[Docket No. 99-SW-62-AD]

Airworthiness Directives; Eurocopter France Model SA-365C, C1, C2, N, and N1; AS-365N2 and N3; and SA-366G1 Helicopters

ACTION: Notice of proposed rulemaking (NPRM).

Figure 1

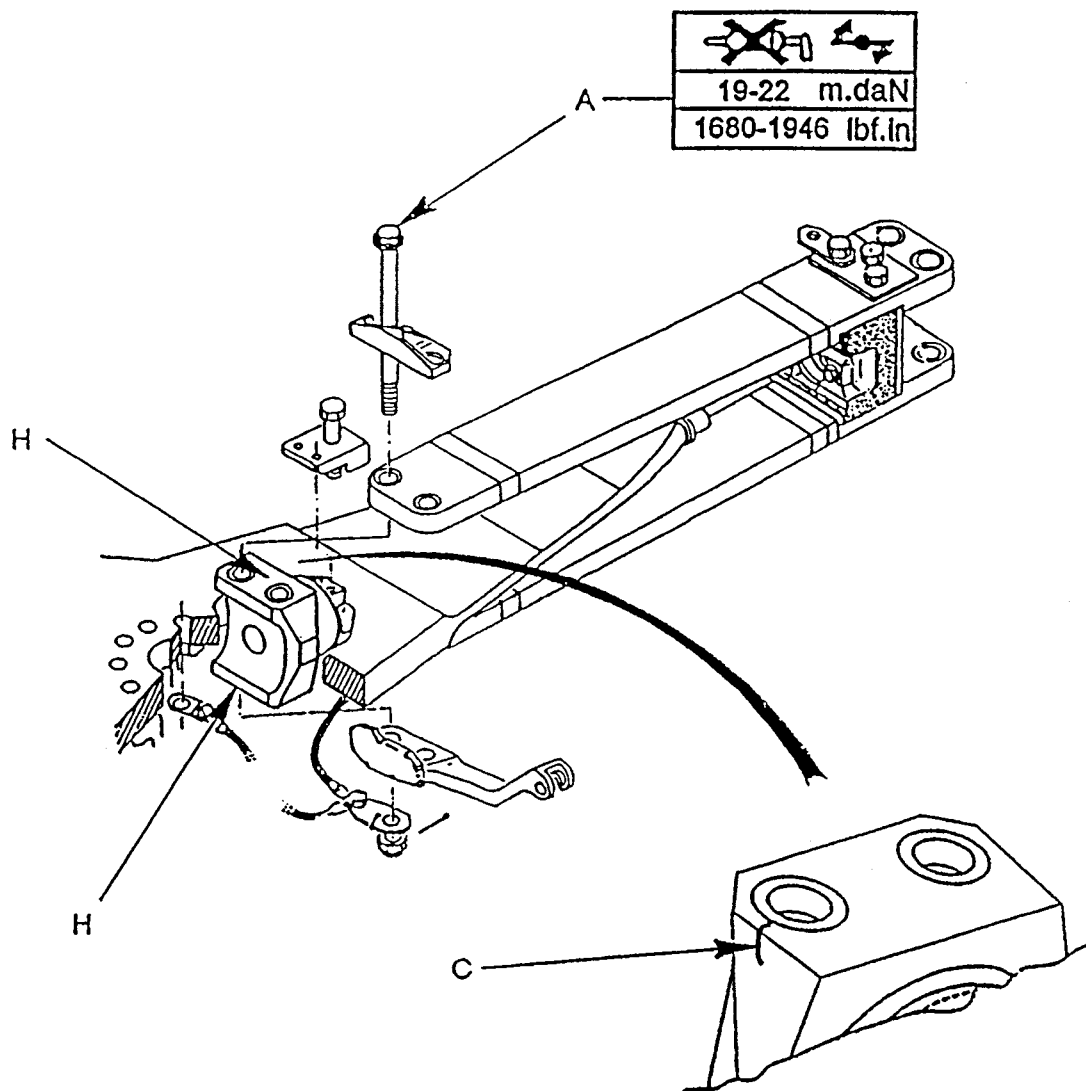
(a) Inspect the tightening torque of the bolts as indicated by "A" in Figure 1.

(1) If tightening torque is equal to or less than 12 m.daN (88.4 lb-ft), remove the bearing and conduct a dye penetrant inspection for cracks on the two contact surfaces identified as "H" in Figure 1.

(i) If a crack is detected, replace the bearing with an airworthy bearing.

(ii) If no crack is detected, reinstall the bearing.

(2) If the tightening torque is greater than 12 m.daN (88.4 lb-ft), then tighten the torque to 19-22 m.daN (140-162.2 lb-ft).
